MILITARY SPECIFICATION SHEET

CAPACITORS, FIXED, CERAMIC DIELECTRIC
(TEMPERATURE COMPENSATING),
ESTABLISHED AND NON-ESTABLISHED RELIABILITY,
STYLES CCR81 and CC81

This amendment forms a part of Military Specification Sheet MIL-C-20/32, dated 25 May 1973, and is approved for use by all Departments and Agencies of the Department of Defense.

FIGURE 1. Style CCR81 and CC81 capacitors.

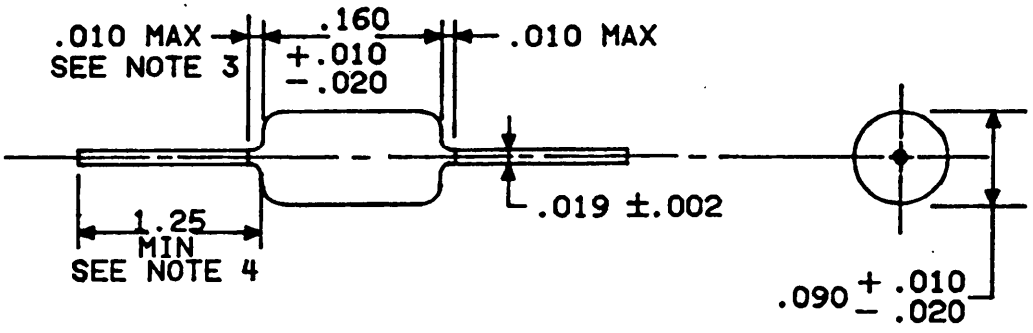
* FIGURE 1, delete and substitute:

NOTES:
1. Dimensions are in inches.
2. Metric equivalents are given for general information only and are based upon 1.00 inch = 25.4 mm.
3. Nonconductive material shall not extend more than .010 inch (.25 mm) beyond the ends of the capacitor body.
4. Lead length may be a minimum of 1.00 inch (25.4 mm) long for use in tape and reel packaging, when specified in the ordering data.
